STATE OF NORTH CAROLINA
DEPARTMENT OF TRANSPORTATION

MEMO TO: Roadway Design Project Engineers
FROM: Jay A. Bennett, PE
State Roadway Design Engineer
DATE: October 21, 2008
SUBJECT: Concrete Transitional Section for Catch Basins and Drop Inlets

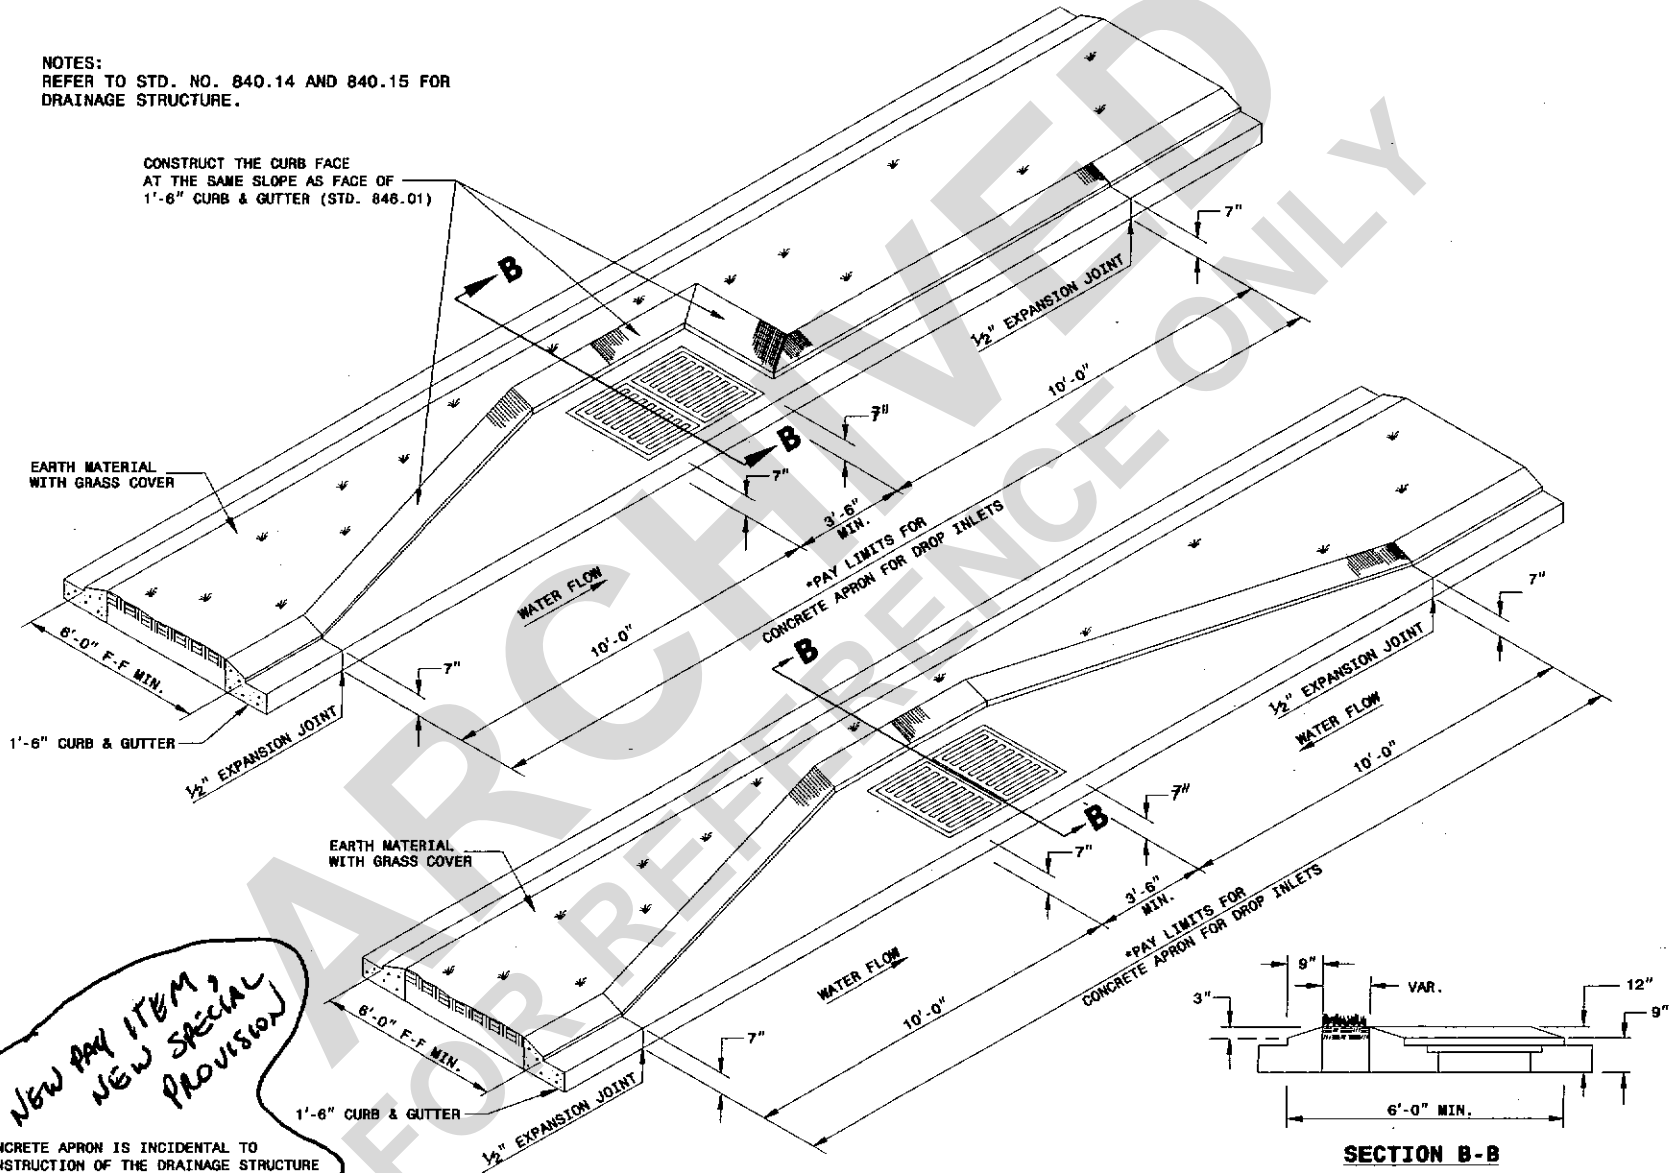
Beginning with the January 20, 2009 Letting, two additional pay items have been added to Transport:
Concrete Transitional Section for Catch Basins – Per Each
Concrete Transitional Section for Drop Inlets – Per Each.

The Drainage Summary Sheets in the cell library have been modified to reflect the changes. Please begin using the new Drainage Summary Sheets with the January 20, 2009 Letting.

ENGLISH STANDARD DRAWING FOR
METHOD FOR PLACEMENT OF
DROP INLETS IN GRASSED MEDIAN
(USING 1'-6" CURB & GUTTER)

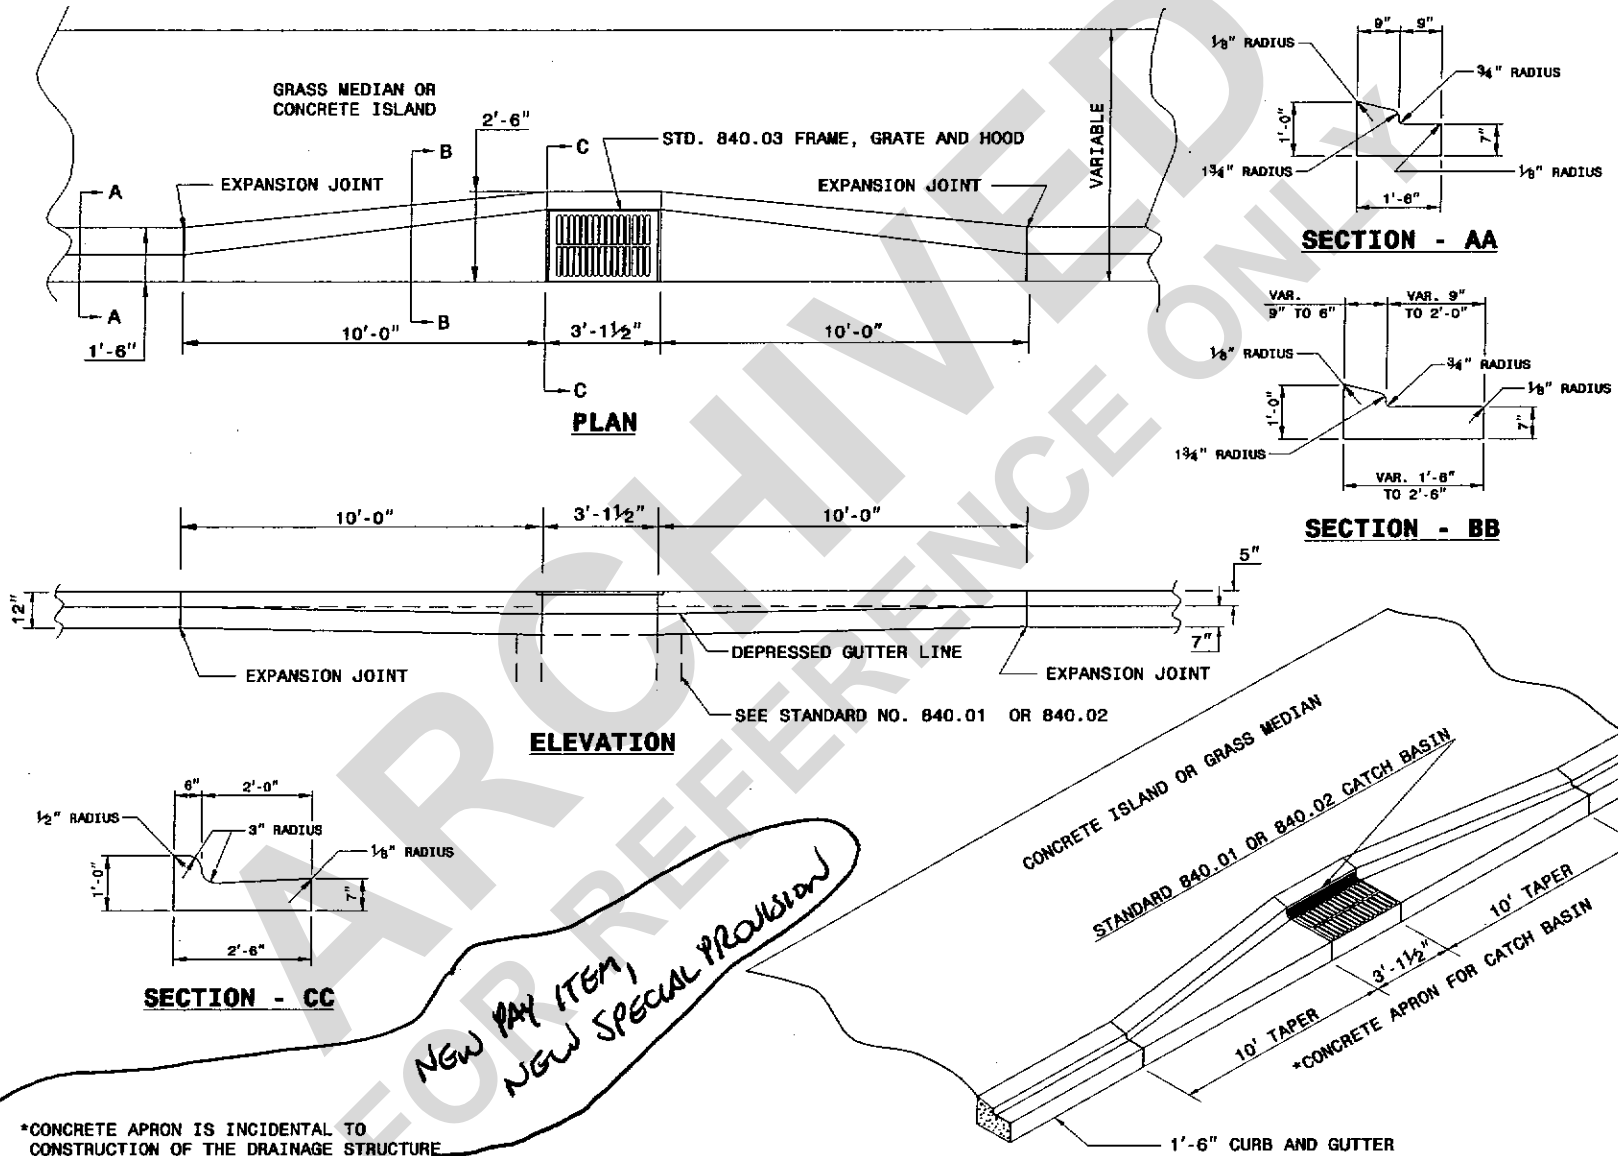
*NEW PAY ITEM,
NEW SPECIAL
PROVISION*

*CONCRETE APRON IS INCIDENTAL TO
CONSTRUCTION OF THE DRAINAGE STRUCTURE

NOW: PER EACH, CONCRETE TRANSITIONAL SECTION FOR DROP INLETS

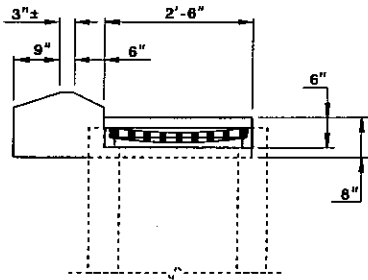
*NEW PAY ITEM,
NEW SPECIAL PROVISION*

*CONCRETE APRON IS INCIDENTAL TO CONSTRUCTION OF THE DRAINAGE STRUCTURE

NOW : PER EACH, CONCRETE TRANSITIONAL SECTION FOR CATCH BASINS

ENGLISH STANDARD DRAWING FOR
**METHOD FOR PLACEMENT OF
DROP INLETS IN CONCRETE ISLANDS**

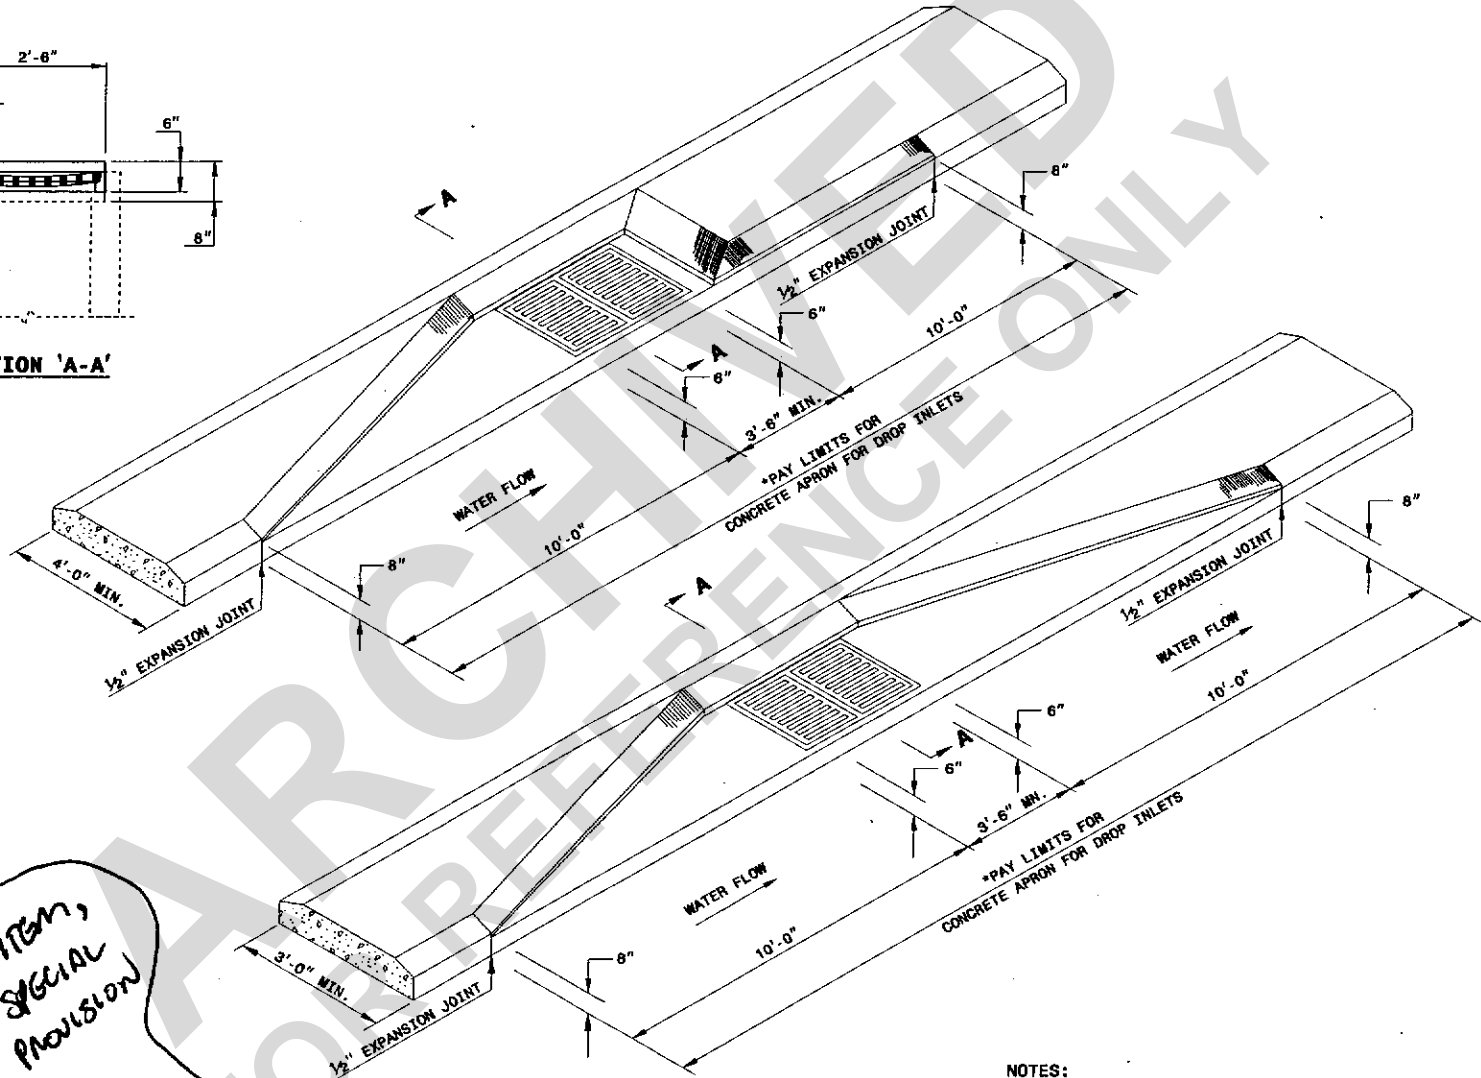
*New pay item,
new special
provision*

*CONCRETE APRON IS INCIDENTAL TO
CONSTRUCTION OF THE DRAINAGE STRUCTURE

Now: PER EACH, CONCRETE TRANSITIONAL SECTION FOR DROP INLETS
